## APPLICATION FOR PERMIT TO DRILL, DEEPEN, OR PLUG BACK

2. NAME OF OPERATOR Northwest Pipeline Corporation		6. IF INDIAN, ALLOTTEE OR TRIBE NAME	
3. ADDRESS OF OPERATOR P.O. Box 90, Farmington, New Mexico 87401		7. UNIT AGREEMENT NAME San Juan 32-7 Unit

14. DISTANCE IN MILES AND DIRECTION FROM NEAREST TOWN OR POST OFFICE* 20 Miles South of Ignacio, Colorado		9. WELL NO. #69	
15. DISTANCE FROM PROPOSED* LOCATION TO NEAREST PROPERTY OR LEASE LINE, FT. (Also to nearest orig. unit line, if any) 790'		10. FIELD AND POOL, OR WILDCAT Basin Dakota

SUNDRY NOTICES AND REPORTS ON WELLS

Form C-102  
Revised 10-1-78STATE OF NEW MEXICO  
OIL AND MINERALS DEPARTMENT

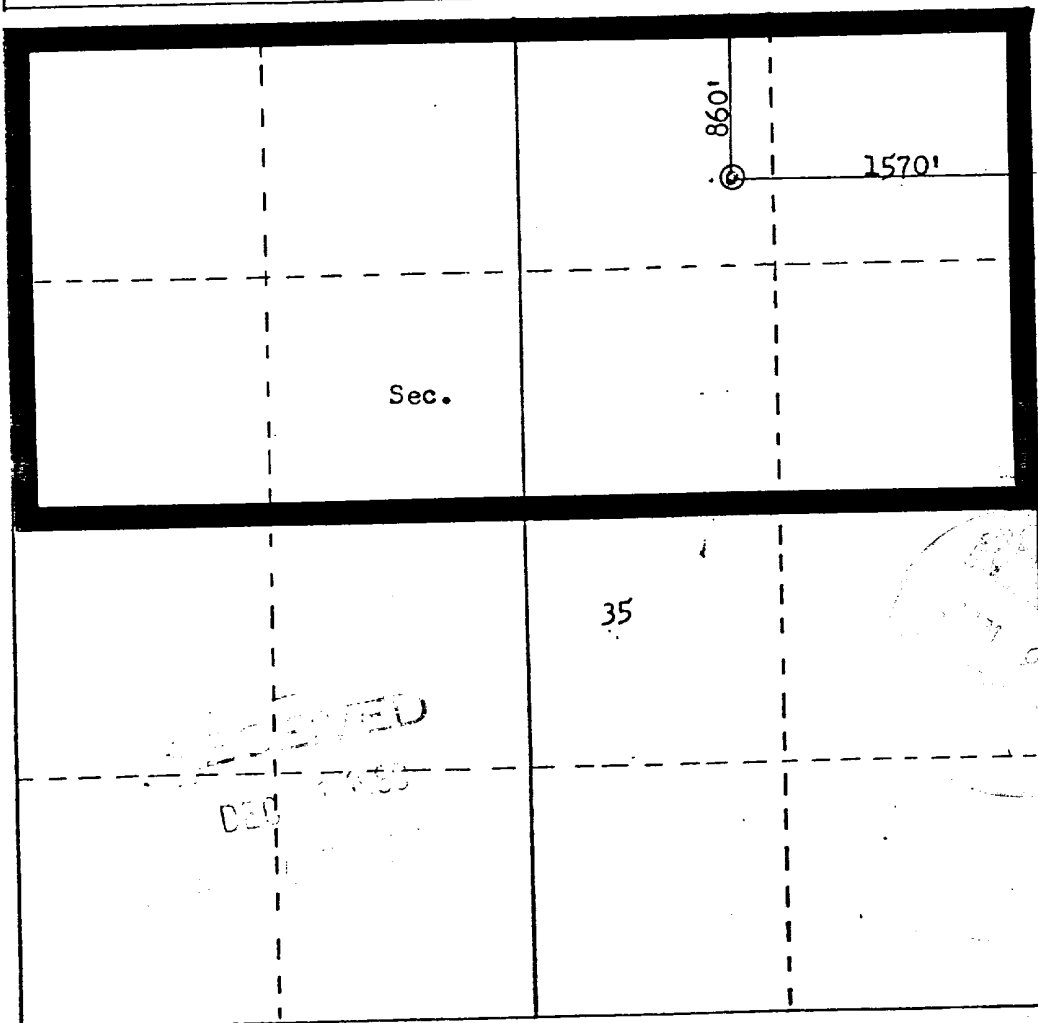
This well location has been changed due to archaeological findings on location.

Old Location: 790' FNL & 880' FEL  
New Location: 860' FNL & 1570' FEL
